Bulletin: CLIB-0012

Topic: Elimination of 15.5" Solo XL and Easy-Pedal XL Clutch Product

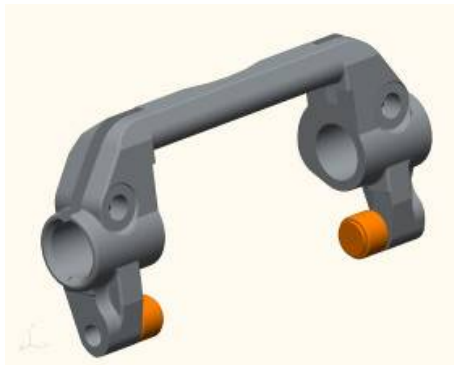
With the release of the 15.5" Solo and Easy-Pedal Advantage clutch product family the 15.5" Solo XL and Easy-Pedal XL is being eliminated from the Eaton clutch product offering. . The enhancements that have been made to the Solo and Advantage release bearing and the release sleeve bushing provide the robustness that does not require the need for a roller yoke.

The 15.5" Solo XL and Easy-Pedal XL product required the use of the 97-509-10-3X XL Roller Yoke.

The 15.5" Solo and Easy-Pedal Advantage clutch uses standard release yoke part number 85533 (105C137).

When replacing the 15.5" Solo XL or Easy-Pedal XL product with the 15.5" Solo or Easy-Pedal Advantage product, or remanufactured clutch offerings, it will be necessary to replace the 97-509-10-3X roller yoke with the 85533 (105C137) standard release yoke.
